Installation Update - CS1200

These instructions clarify the installation protocol recommended by DiversiTech for product CS1200.

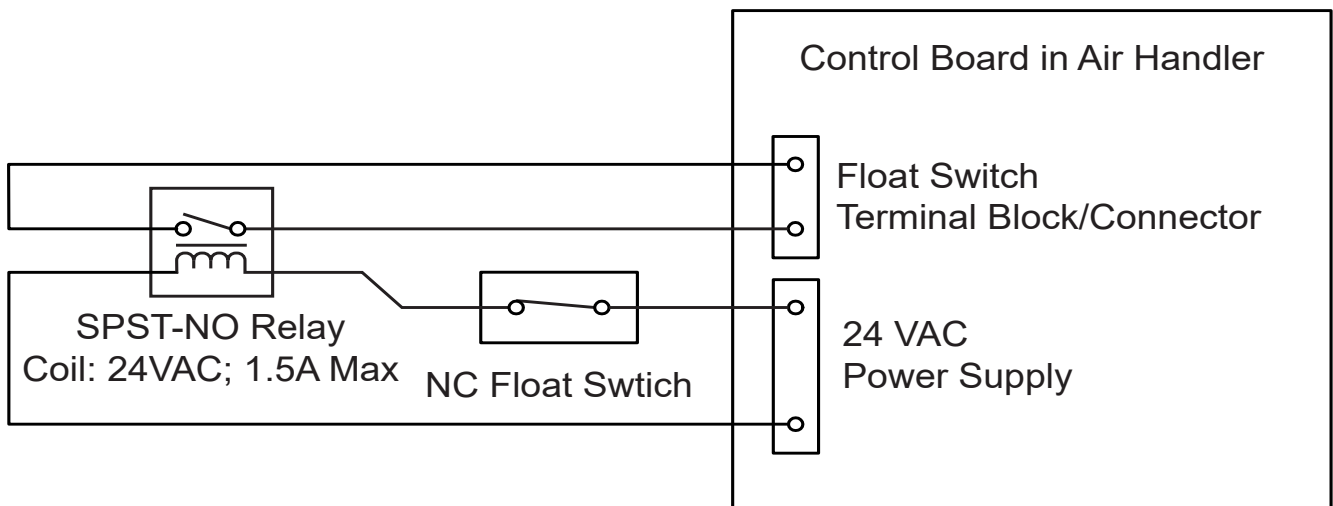
Description: Some Communicating HVAC Systems using a dedicated condensate overflow safety switch shutdown input will require the use of an additional (optional) relay. The additional relay is only required if, after the installation of the above products, the HVAC system does not properly shutdown during verification testing.

And finally, check that the system shuts down as expected. If the unit does not shutdown, your unit is more sensitive to switch characteristics than traditional systems and, therefore, requires a relay. Please proceed to implement the relay solution outlined below.

Action: Use a normally open SPST relay with a 24VAC coil (DiversiTech part # D90-290Q or equivalent) to break the condensate overflow safety shutdown input circuit. DiversiTech condensate switch CS1200 should be used to make or break control power to the relay coil.
